Access Compliance Report

Public Rights-of-Way

Intersection ID: 5704	Main Street: W W T HARRIS BV	Cross Street: N TRYON ST	Location:	N
ADA ID: F2ED73AEDD11	Ramp Type: Directional1	Initial Pass/Fail: Fail	Overall Compliance: No	Severity Score: 25

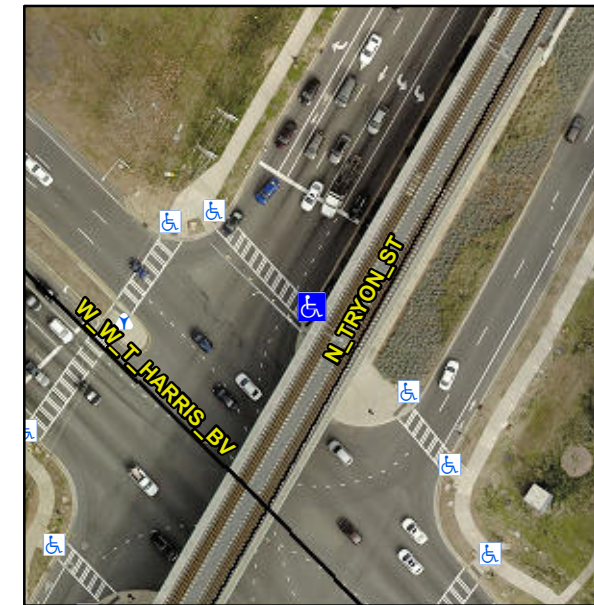
LOCATED ON MEDIAN

R304.2.2

Compliance	Description	Data	Compliance	Description	Data
N/A	Ramp Length (in)	103.0	N/A	Grade Break?	N/A
Yes	Ramp Width (in)	119.0	N/A	Grade Break Slope (%)	0.0
No	Ramp Slope (%)	15.1	N/A	Grade Break XSlope (%)	0.0
Yes	Ramp XSlope (%)	0.2			
N/A	Flare Type LT	N/A	N/A	Flare Type RT	N/A
N/A	Flare Slope LT (%)	N/A	N/A	Flare Slope RT (%)	0.0
N/A	Flare Traversable LT?	N/A	N/A	Flare Traversable RT?	N/A
N/A	Landing Length (in)	0.0	N/A	DWS Provided?	N/A
N/A	Landing Width (in)	0.0	N/A	DWS Contrast?	N/A
N/A	Landing Slope (%)	0.0	N/A	DWS Length (in)	N/A
N/A	Landing X Slope (%)	0.0	N/A	DWS Full Width?	N/A
N/A	Landing Curb? (Y/N)	N/A	N/A	DWS Offset LT (in)	N/A
N/A	Shared Landing?	N/A	N/A	DWS Offset RT (in)	N/A
N/A	Gutter Ponding?	0.0	N/A	Gutter Slope (%)	N/A
N/A	Gutter Lip Ht (in)	1.0	N/A	Gutter X Slope (%)	N/A
N/A	Painted X Walk1?	No		Road Slope (%)	5.2
	X Walk 1 Direction	To NW		Road X Slope (%)	0.4
	X Walk 1 Width (in)	N/A		Clear Space?	N/A

Remove & Replace Entire Ramp.
